ADDENDUM NUMBER ONE

DATE: March 28, 2019

PROJECT: City of Myrtle
Renovations to 13th Ave. South for Facilities Maintenance

A4.0

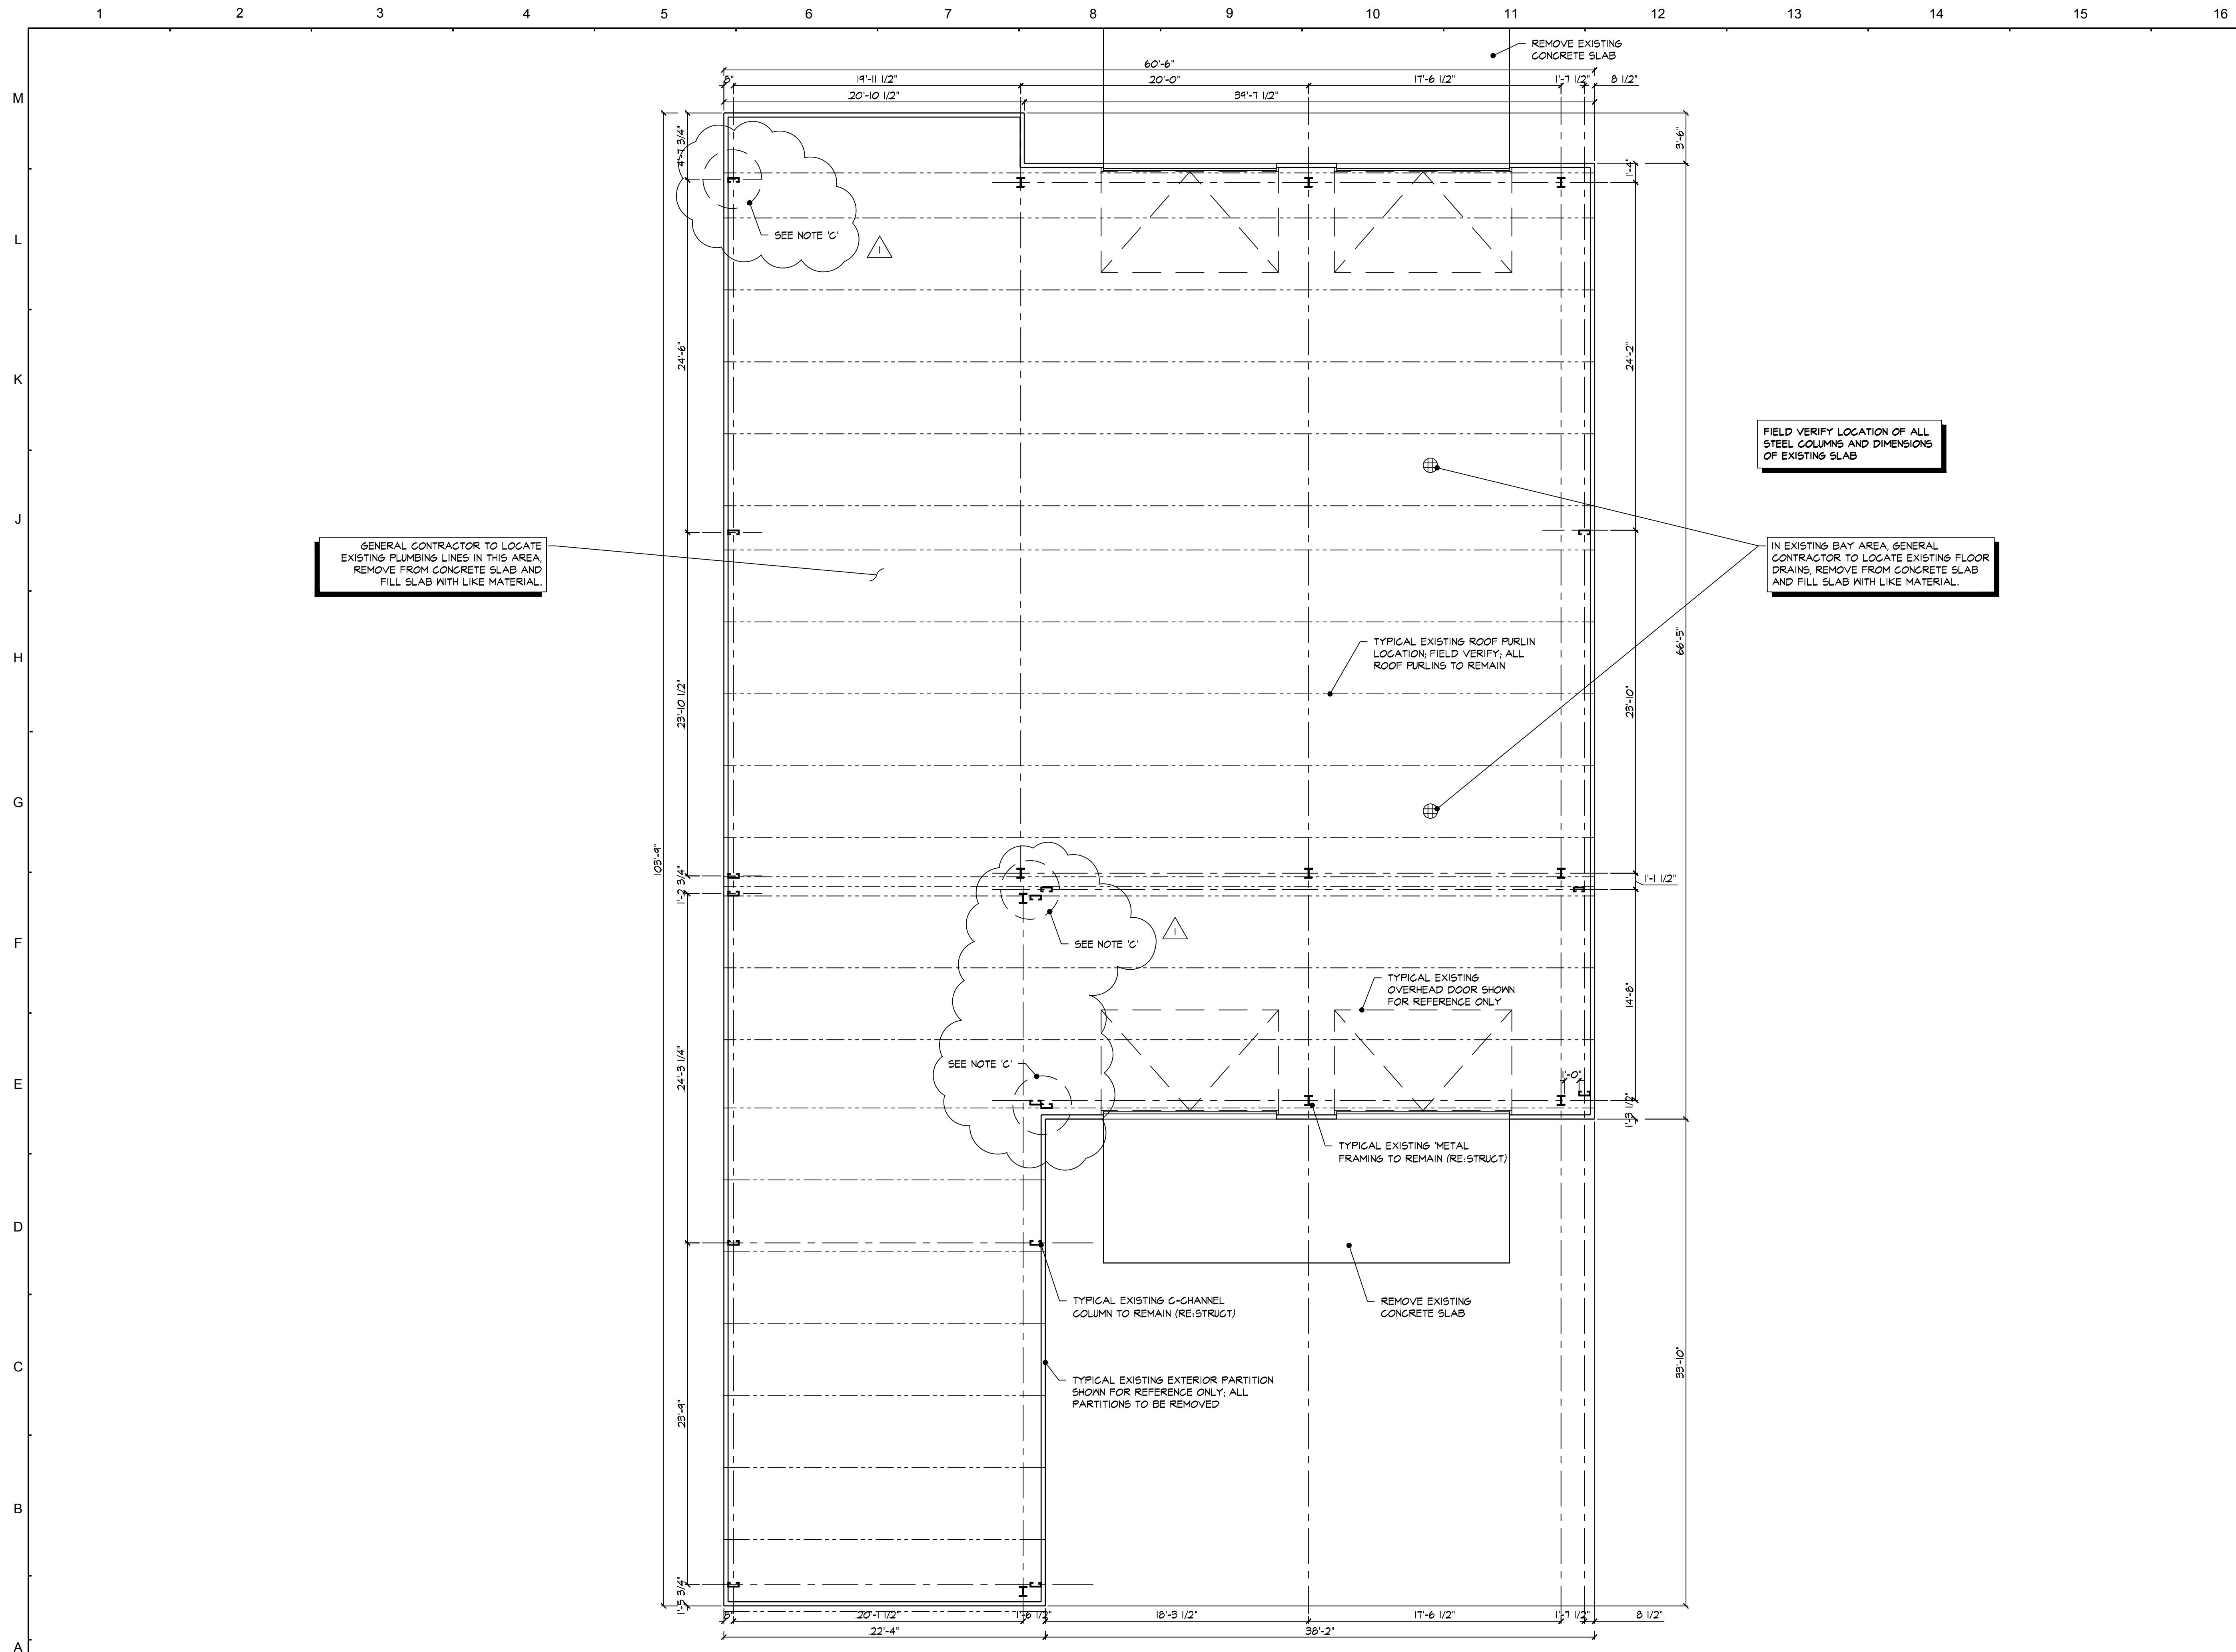
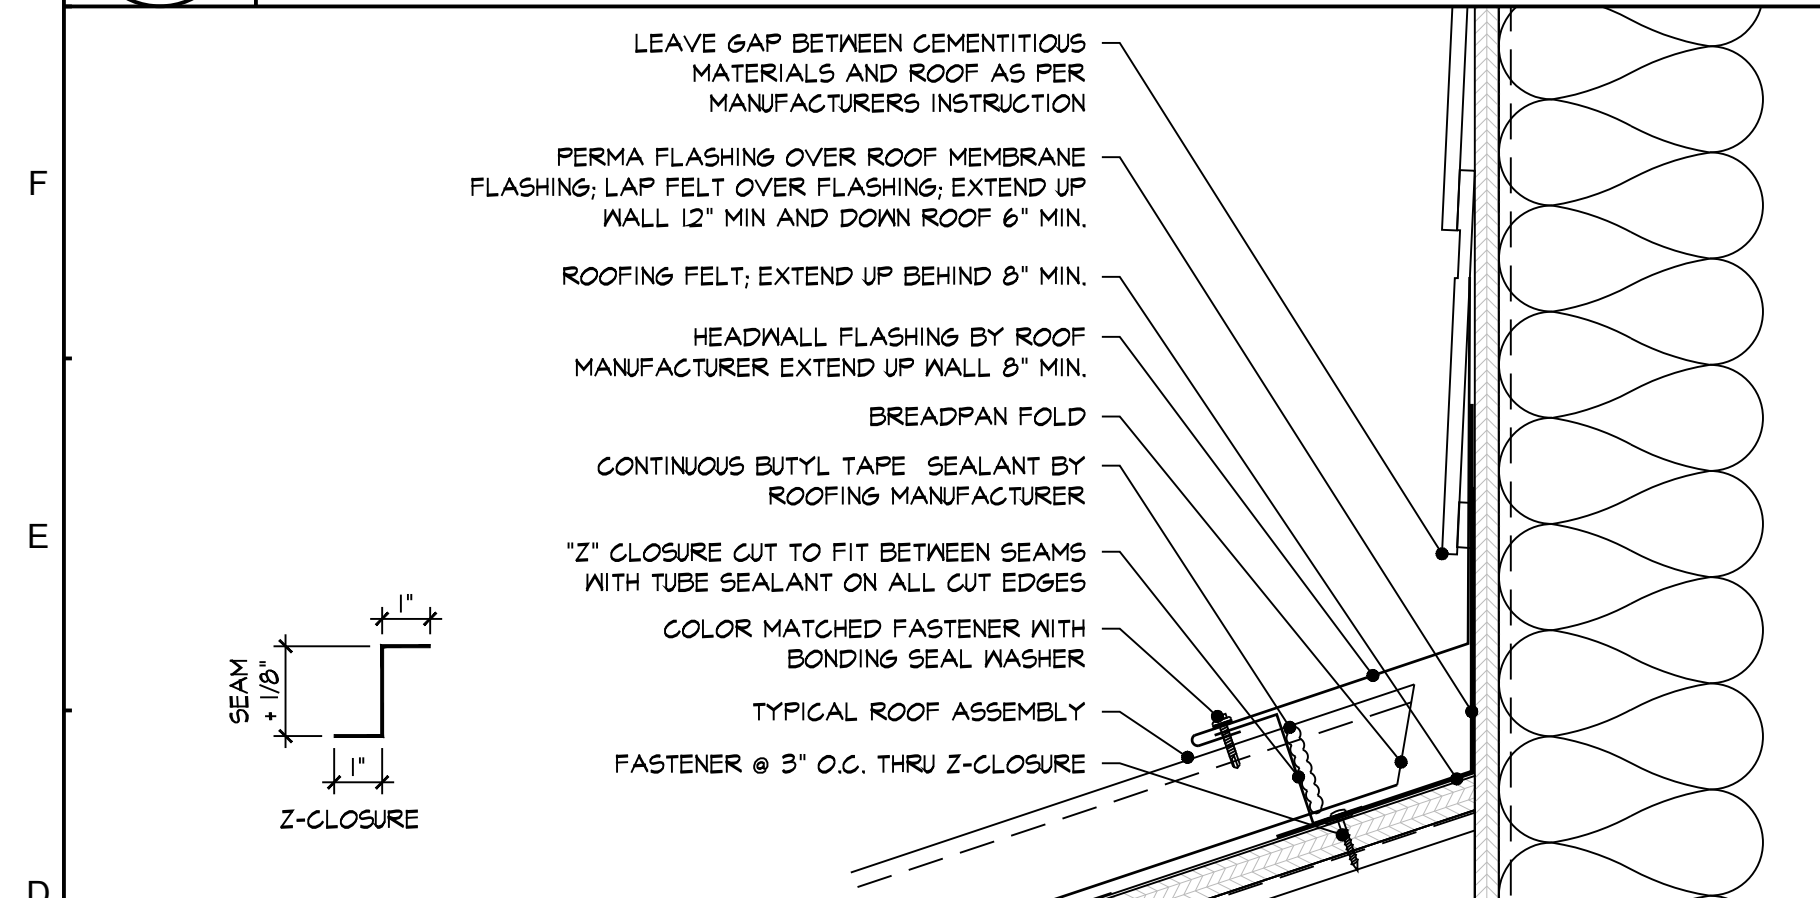
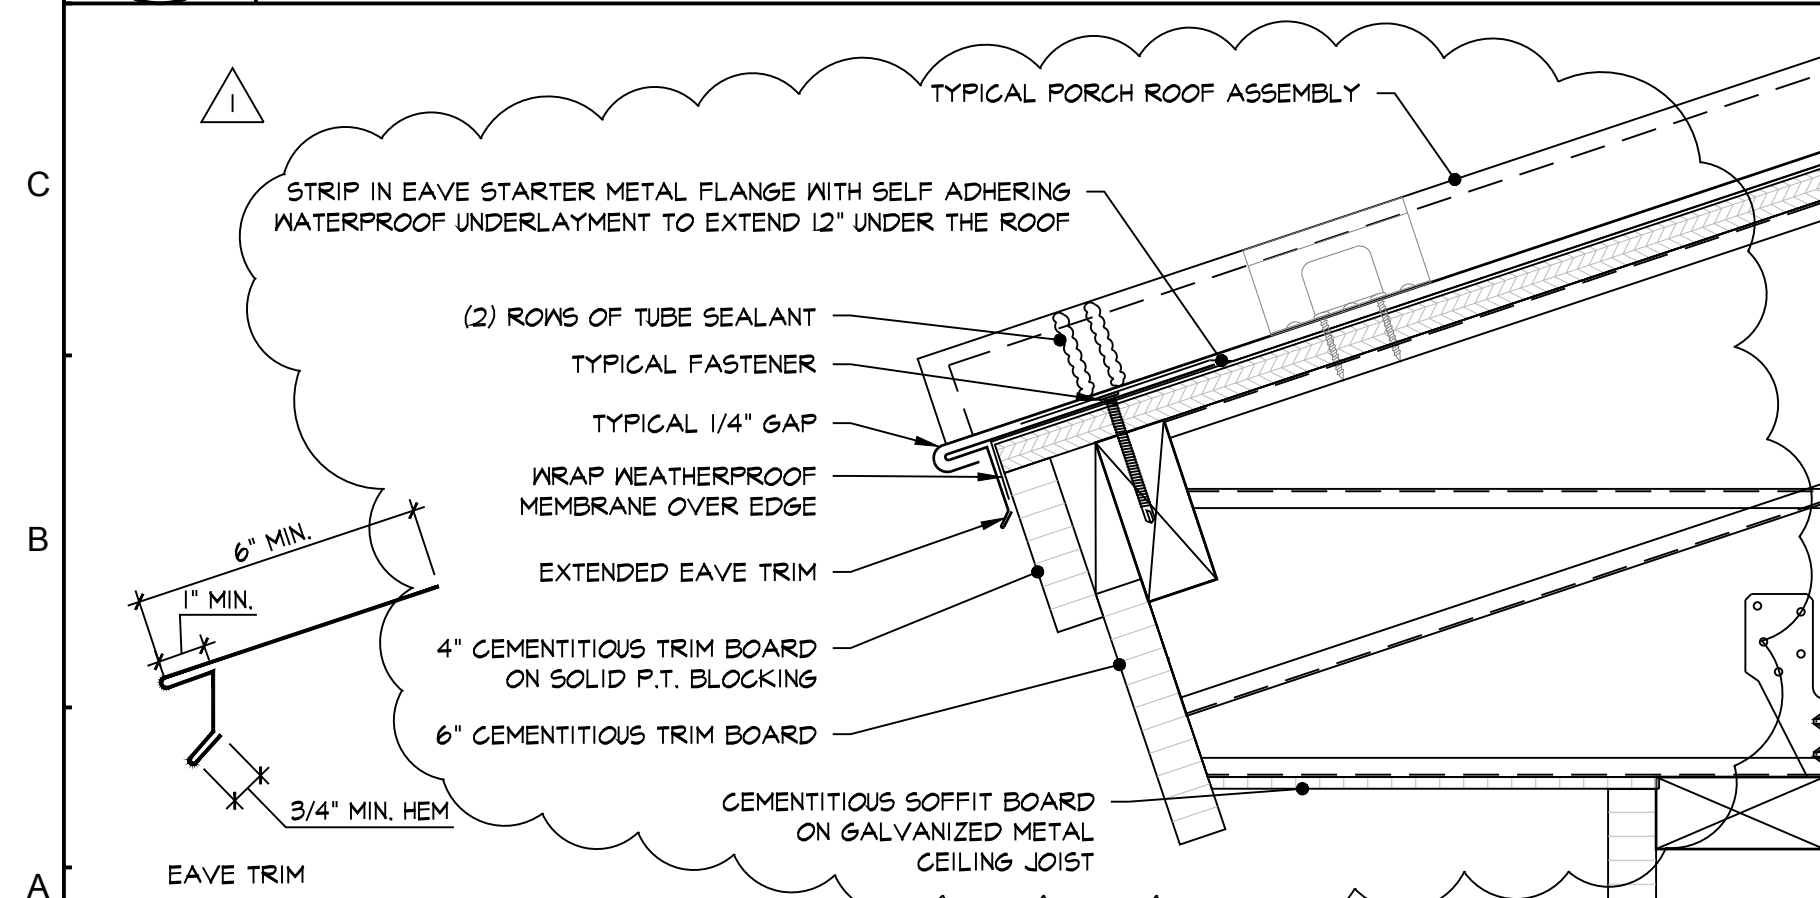
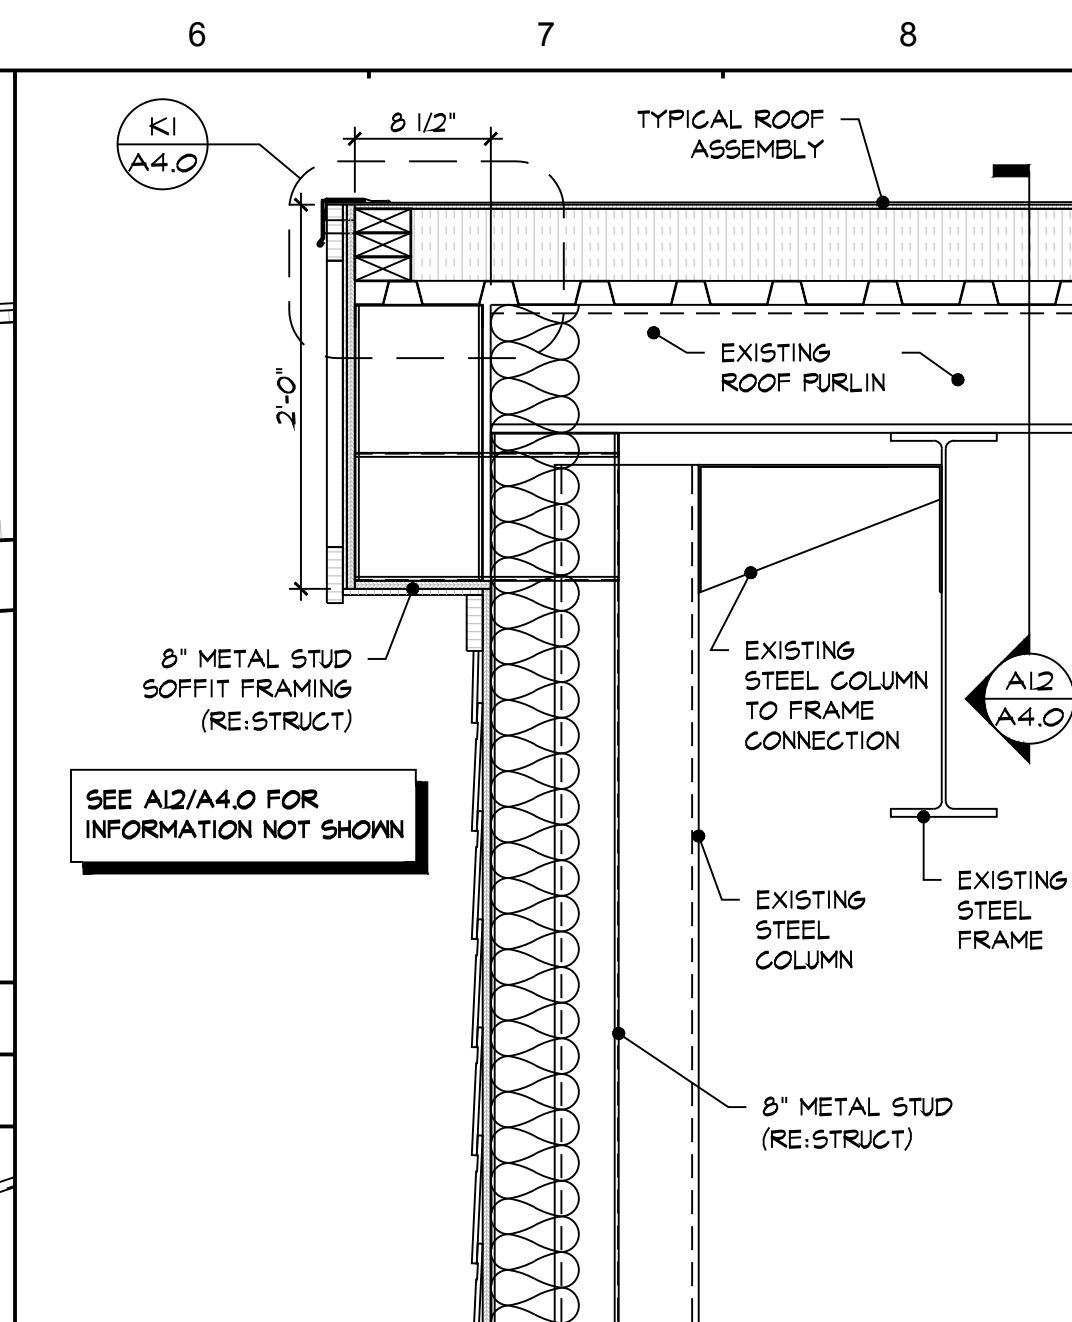
Revisions reflect modification of porch framing from wood to metal studs and metal decking.
